Subject: Response to Request for Additional Information Regarding Relief Requests PRR-004, PRR-005, PRR-007 and PRR-010 for the Inservice Testing Program Third Ten-Year Interval

**Enclosure
To NRC-10-0023**

**Fermi 2 NRC Docket No. 50-341
Operating License No. NPF-43**

**Response to Request for Additional Information Regarding
Relief Requests PRR-004, PRR-005, PRR-007 and PRR-010
for the Inservice Testing Program Third Ten-Year Interval**

Figure 1 - VLSC

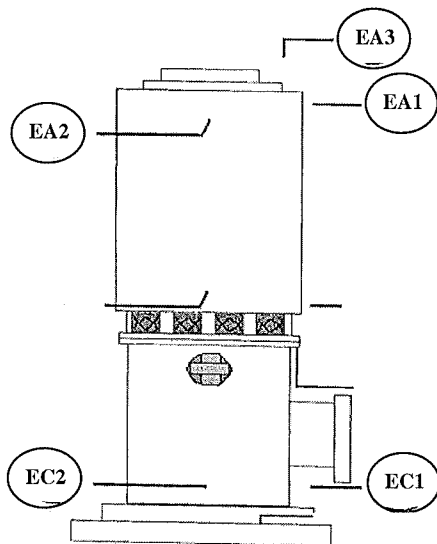
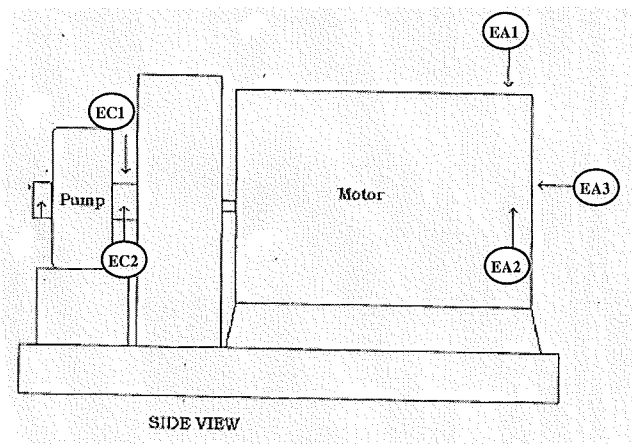
Relief Request PRR-005 lists all the applicable pumps on page 47 thru 48 and provides measured reference vibration values at points EA1, EA2, EA3, EC1, and EC2. (1) Please describe the physical location of these points, and (2) Please confirm that pumps' vibration values provided are based on historical data.

- (2) Vibration monitoring point locations are shown on Figures 1 and 2 below.

The measured reference vibration values provided in the Relief Request are the IST reference values for the particular monitoring point. These reference values were established during baseline testing at reference flow when the pump was known to be operating acceptably.
